REVISED PROPOSAL FOR DRAFT CORRIGENDUM 1 TO REGULATION No. 112
(Headlamps emitting an asymmetrical passing beam)

Transmitted by the Expert from the Working Party "Brussels 1952" (GTB)

"Figure D
Primary Driving Beam

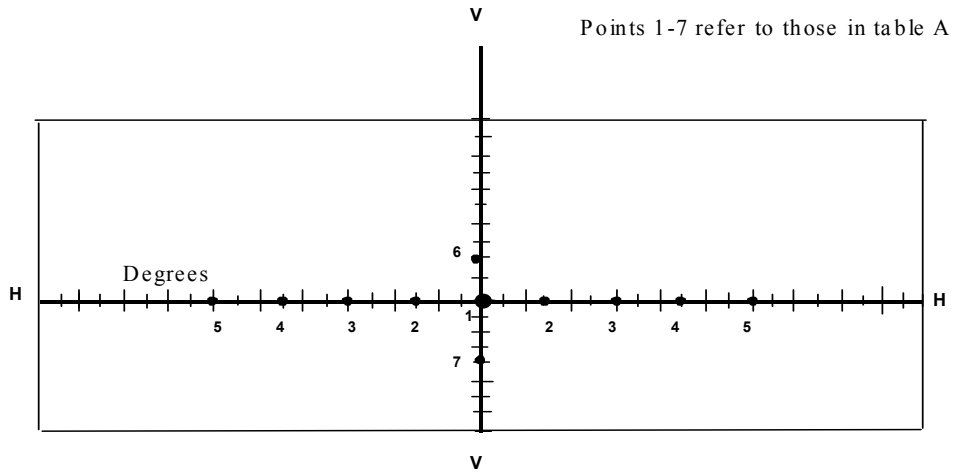
Table A - Class C Headlamp -Primary high beam

Refer to Figure D for details of test point positions

TEST POINT NUMBER	TEST POINT LOCATION	Required illumination in lux	
		Min.	Max.
1	H-V (1)	(1)	---
2	H-3R & 3L	20	---
3	H-6R & 6L	7	---
4	H-9R & 9L	4	---
5	H-12R & 12L	1.2	---
6	2U-V	2	---
7	4D-V	---	(2)
	MAX. LUMINOUS INTENSITY	50	180.0

Add at the end figures D and E, to read:

Figure E
Secondary Driving Beam

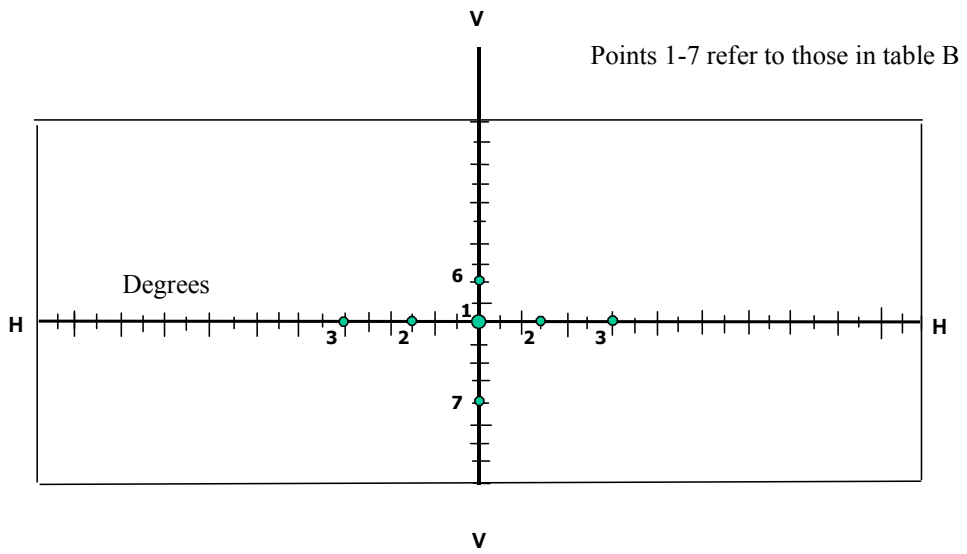
Table B - Class C Headlamp - Secondary high beam operated with a passing beam headlamp or a primary driving beam headlamp

Refer to Figure E for details of test point positions

TEST POINT NUMBER	TEST POINT LOCATION	Required illumination in lux	
		Min.	Max.
1	H-V (1)	(1)	---
2	H-3R & 3L	20	---
3	H-6R & 6L	7	---
6	2U-V	2	---
7	4D-V	---	(2)
	MAX. LUMINOUS INTENSITY	50	180
